E87-09/10
1010.1 (IFC [B] 1010.1)

Proposed Change as Submitted

Proponent: Jon Siu, City of Seattle, representing Washington Association of Building Officials Technical Code Development Committee

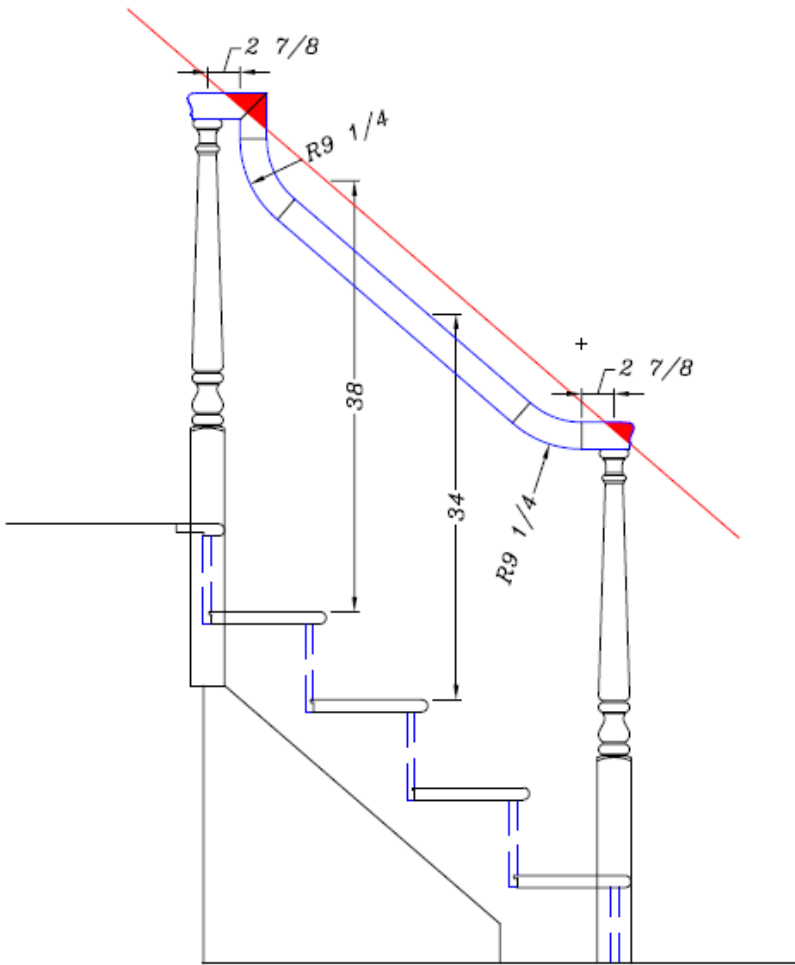
Reason: The above information is being requested to clarify the Code. Fittings such as easings and gooseneck risers are commonly used features intended to provide rail continuity at locations where a straight transition is not possible. Incorporating such features is consistent with the provisions of IBC Section 1012.4 (Continuity) and with standard architectural and construction practice.

Unfortunately, the current wording of the Code, although it does indicate that height requirements should be "measured above stair tread nosings," does not clearly state that the height requirements do not apply over landings, at winder treads, where handrails meet a guardrail, or when used at the start of a flight. Inspectors, plan reviewers, and other building code officials in many jurisdictions are currently not accepting handrail fittings such as easings or gooseneck risers which are provided to maintain continuity.

1012.2 (IFC [B] 1012.2) Height. Handrail height, measured above stair tread nosings, or finish surface of ramp slope shall be uniform, not less than 34 inches (864 mm) and not more than 38 inches (965 mm). Handrail height of alternating tread devices and ship ladders, measured above tread nosings, shall be uniform, not less than 30 inches (762 mm) and not more than 34 inches (864 mm).

1013.2 (IFC [B] 1013.2) Height. Required guards shall not be less than 42 inches (1067 mm) high, measured vertically as follows:

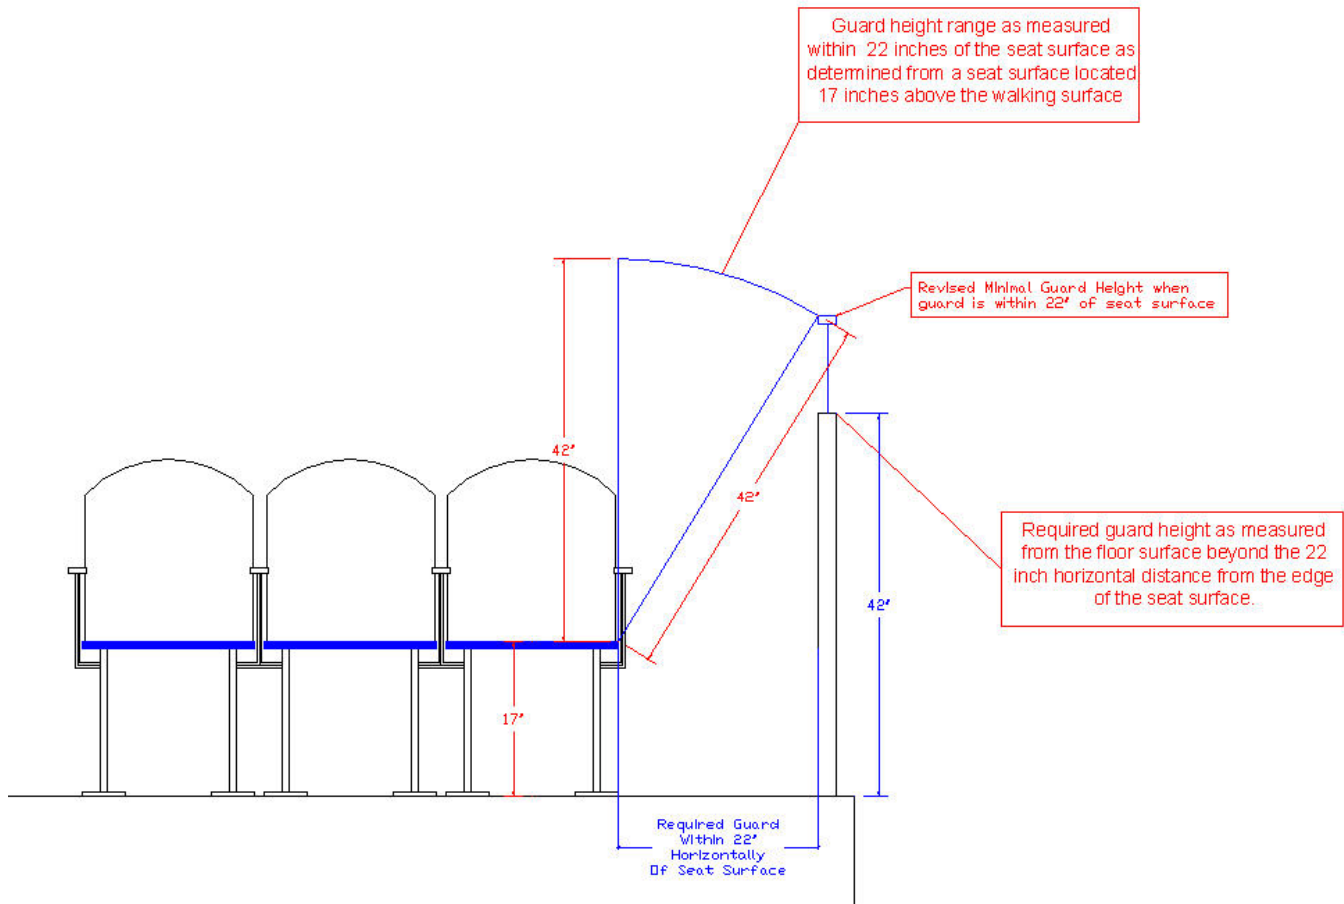
Commenter's Reason: As noted by the code committee, there was some confusion as to how to make the measurements as well as the need to coordinate these changes with experts in assembly seating. In response, the CTC has partnered with the proponent of code change E147 who is an expert in assembly seating. Further, the CTC provides the following illustrations which show the relationship between the height of the guard and its proximity to the seating surface. This comment should be considered with E147.

If the code change is approved, the illustrations is intended to be added to the IBC Commentaries. The following illustrates the applications of the code requirements:

1. From the adjacent walking surfaces;
2. From a seat surface of adjacent fixed seating, with or without arm or back rests, within 22 inches measured horizontally of a required guard, the guard height shall provide a minimum 42 inches measured diagonally between the top of the guard and the nearest edge of the seat surface;
3. On stairs, from the line connecting the leading edges of the tread nosings; and
4. On ramps, from the ramp surface at the guard.

R312.2 Height. Required guards at open-sided walking surfaces, including stairs, porches, balconies or landings, shall be not less than 36 inches high measured vertically as follows:

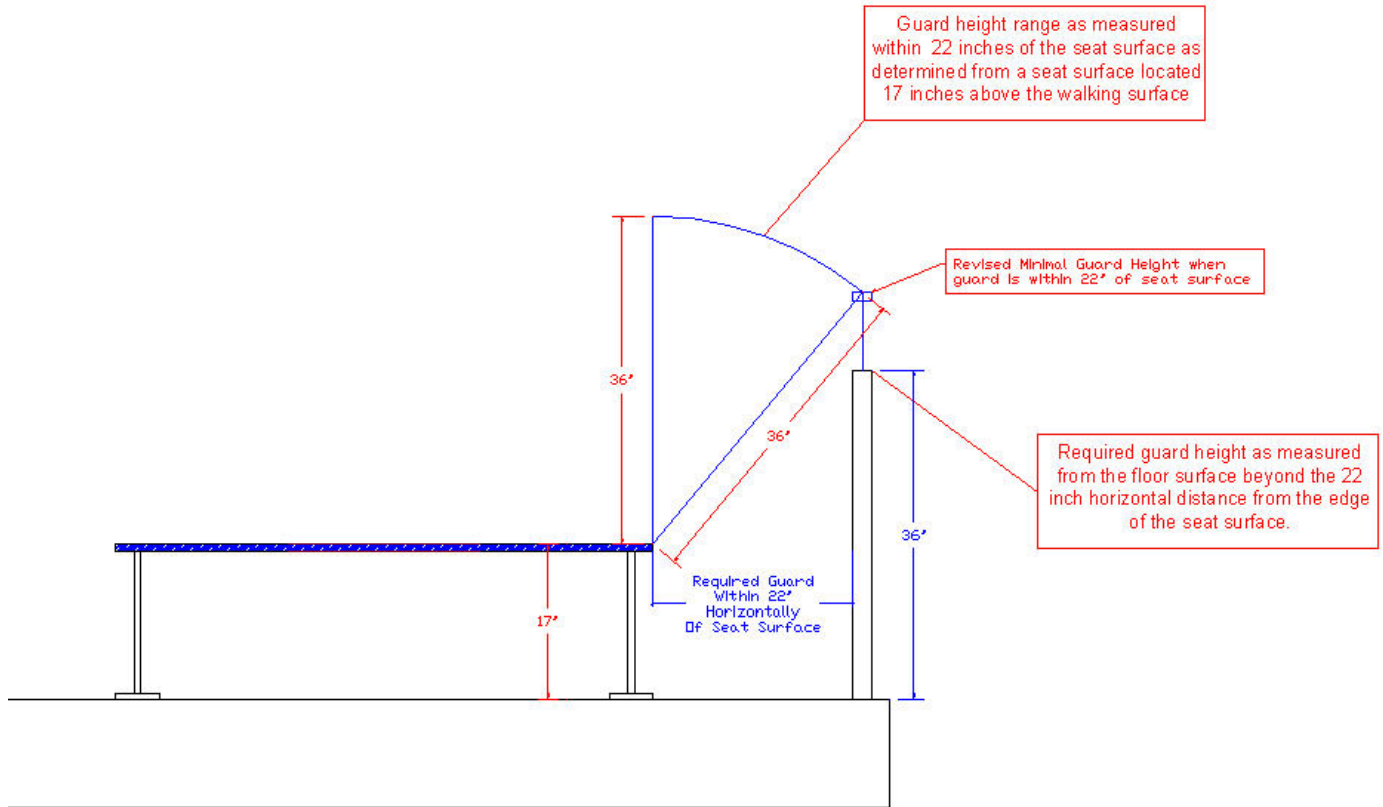
Commenter's Reason: As noted by the code committee, there was some confusion as to how to make the measurements as well as the need to coordinate these changes with experts in assembly seating for the IBC requirements. If the code change is approved, the illustrations is intended to be added to the IRC Commentaries. The following illustrates the applications of the code requirements:

1. From the adjacent walking surface;
2. From a seat surface of adjacent fixed seating, with or without arm or back rests, within 22 inches measured horizontally of the required guard, the guard height shall provide a minimum 36 inches measured diagonally between the top of the guard and the nearest edge of the seat surface;
3. On stairs, from the line connecting the leading edges of the tread nosings; and
4. On ramps, from the ramp surface at the guard.

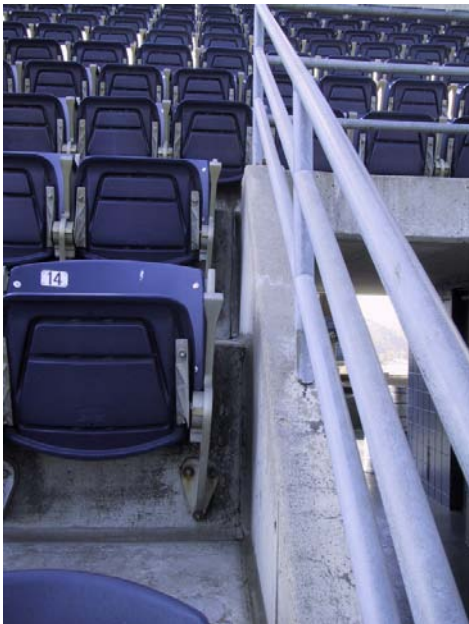
Following are two photographs of self-rising chairs and one of bench seats. The fixed bench seating could serve as a walking surface, however the self-rising chairs are not easily used as a walking surface. 2007 ICC 300 measures vertically above the leading edge of the tread, adjacent walking surface or adjacent bench seat. This proposal maintains how the height of the guard is measured by 1013.2 with the exception of replacing the term "fixed seat" with the term "bench seat" to coordinate with ICC 300 and to enhance clarity that guard height needs to be measured vertically above such seats. Also, the term "bench seat" rather than "seatboard" is commonly used for this type of seating in assembly seating project specifications. An exception was added for self-rising chairs since these seats are not easily used as a walking surface and there is no well defined way to measure these chairs.

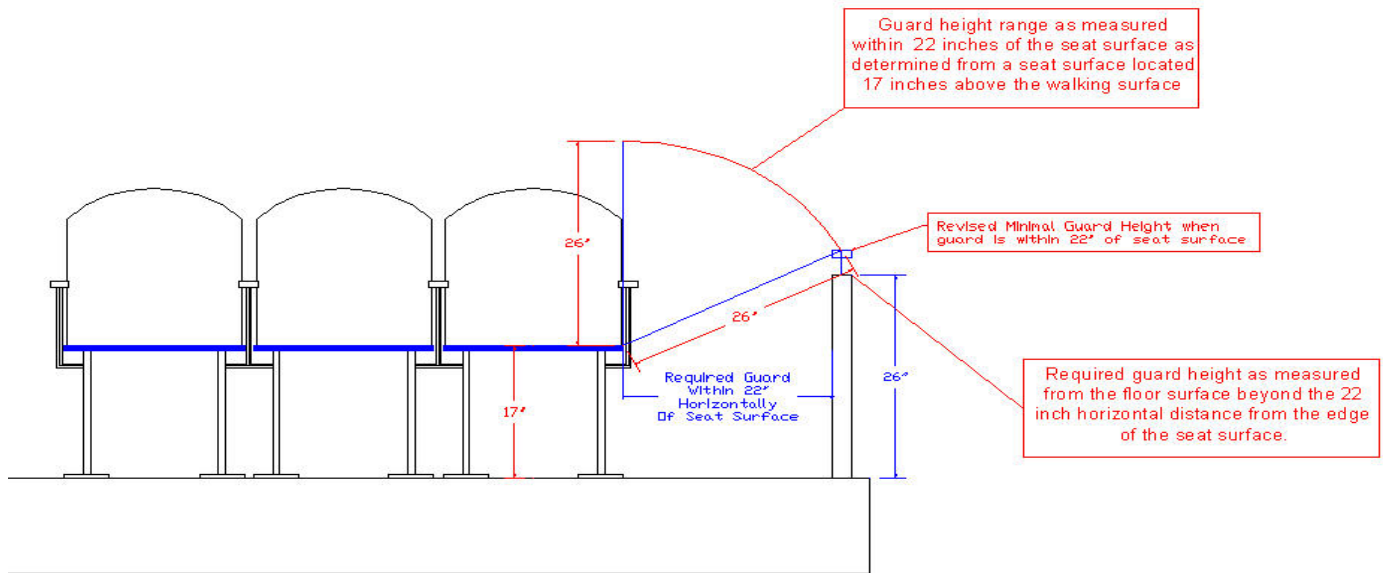
Commenter's Reason: As noted by the code committee, there was a need to coordinate CTC's proposed E100 and Ed Roether's E147 who is an expert in assembly seating design. This comment is in recognition of that need.,

The following illustrate how guards would be measured in assembly seating.

1028.14.2 (IFC [B] 1028.14.2) Sightline-constrained guard heights. Unless subject to the requirements of Section 1028.14.3, a fascia or railing system in accordance with the *guard* requirements of Section 1013 and having a minimum height of 26 inches (660 mm) ~~measured vertically above the adjacent walking surfaces, adjacent bench seat or the line connecting the leading edges of the treads~~ shall be provided where the floor or footboard elevation is more than 30 inches (762 mm) above the floor or grade below and the fascia or railing would otherwise interfere with the sightlines of immediately adjacent seating. At *bleachers*, a *guard* must be provided where required by ICC 300.
